SERVICE BULLETIN NO: 32-003 REF NO: 63

MODIFICATION NO: EC-08-0400 ATA CHAPTER: 32

LANDING GEAR - MAIN GEAR AND DOORS REPLACEMENT OF THE MAIN-GEAR SUPPORT STRUT

Support Strut Removal/Installation Figure 1

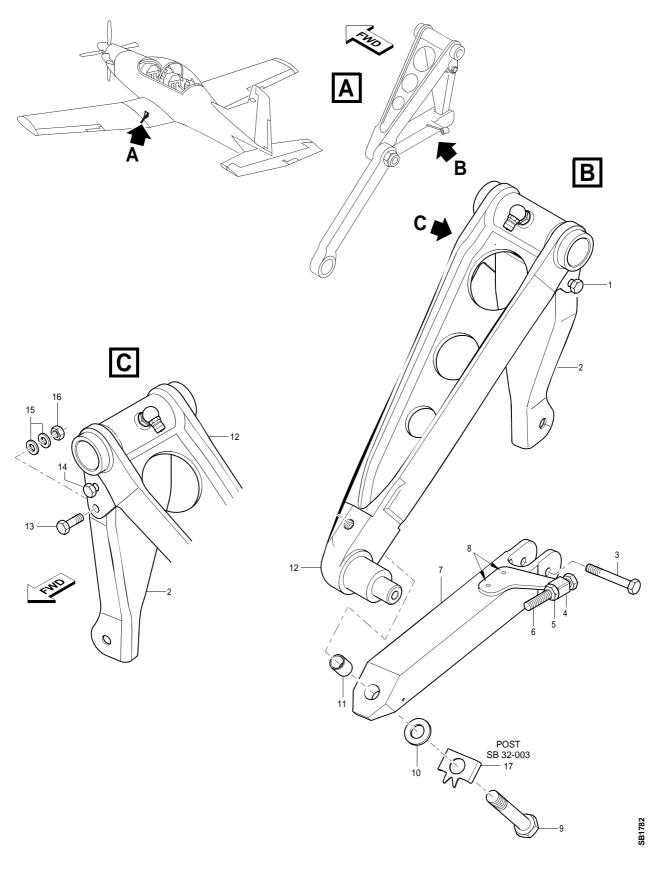
- (1) Remove and discard the lockwire from the bolt (9).
- (2) Remove and discard the bolt (9), the washer (10) and the bush (11) that attach the maingear support strut (7) to the upper folding strut (12).
- (3) Loosen, but do not remove, the bolts (1) and (14).
- (4) Remove the nut (16), the washers (15) and the bolt (13).
- (5) Move the folding strut lever (2) away from the main-gear support strut (7).

- (6) Remove the main-gear support strut (7). If the main-gear support strut (7) is difficult to remove, apply heat to the area.
- (7) Use the applicable size drill and remove the two rivets (8) that attach the support assembly (4) to the main-gear support strut (7). Keep the support assembly (4).
- (8) Discard the main-gear support strut (7).

- (1) Attach the support assembly (4) to the main-gear support strut (7) (P/N 532.10.09.128):
 - (a) Use a 4.1 mm (0.16 in.) diameter drill to make one of the rivet holes in the maingear support strut (7) (P/N 532.10.09.128).
 - (b) Temporarily attach the support assembly (4) to the main-gear support strut (7) (P/N 532.10.09.128) with a gripper pin.

- Apply sealant (Mat. No. P08-057) to the rivets (8) (P/N 939.17.81.255), then install the rivets (8) (P/N 939.17.81.255) to attach the support assembly (4) to the main-gear support strut (7) (P/N 532.10.09.128) (Ref. SRM, 51-40-00, Page Block 1).

- (d) Temporarily install, but do not fully tighten, the bolt (9) (P/N 932.35.14.227), the lock washer (17) (P/N 532.10.09.133) and the washer (10) (P/N 938.75.11.311) to attach the main-gear support strut (7) (P/N 532.10.09.128) to the upper folding strut (12).

Make the Holes in the Main-Gear Support Strut the Correct Size Figure 2

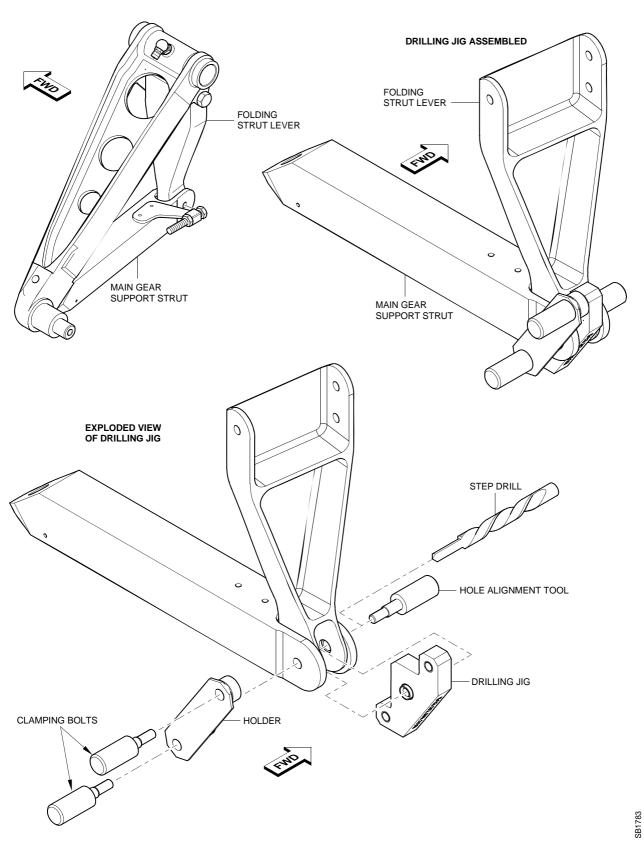
- Put the drilling jig (P/N 513.32.09.119) into one of the holes in the folding strut lever (2). Make sure the step on the drilling jig (P/N 513.32.09.119) engages in the hole of the folding strut lever (2).

- Put the holder (P/N 513.32.09.120) in position on the drilling jig (P/N 513.32.09.119) and install the two clamping bolts (P/N 513.32.09.123). Do not tighten the two clamping bolts (P/N 513.32.09.123).

- <u>3</u> Use the hole alignment tool (P/N 513.32.09.124) to align the holes in the folding strut lever (2) and the main-gear support strut (7) (P/N 532.10.09.128).

- Tighten the bolts (1) and (14)
 - Tighten the two clamping bolts (P/N 513.32.09.123)
 - Tighten the bolt (9).
 - 5 Use the step drill (P/N 513.32.09.122) to increase the diameter of the other hole in the main-gear support strut (7) (P/N 532.10.09.128) to 7.6 mm.

- Put the holder (P/N 513.32.09.120) in position on the drilling jig (P/N 513.32.09.119) and install the two clamping bolts (P/N 513.32.09.123).
 - 8 Use the step drill (P/N 513.32.09.122) to increase the diameter of the other hole in the main-gear support strut (P/N 532.10.09.128) to 7.6 mm.

- 9 Remove the two clamping bolts (P/N 513.32.09.123), the holder (P/N 513.32.09.120) and the drilling jig (P/N 513.32.09.119).
- 10 Remove the bolt (9), the lock washer (17) and the washer (10).
- 11 Loosen, but do not remove, the bolts (1) and (14).
- 12 Remove the nut (16), the washers (15) and the bolt (13). Discard the nut (16).
- 13 Move the folding strut lever (2) away from the main-gear support strut (7).
- 14 Remove the main-gear support strut (7) (P/N 532.10.09.128).
- Use the reamer (P/N 901.80.02.030) and increase the diameter of the holes in the main-gear support strut (7) (P/N 532.10.09.128) to 7.938 + 0.015
 0.0 mm (0.3125 + 0.0006 0.0 in.).
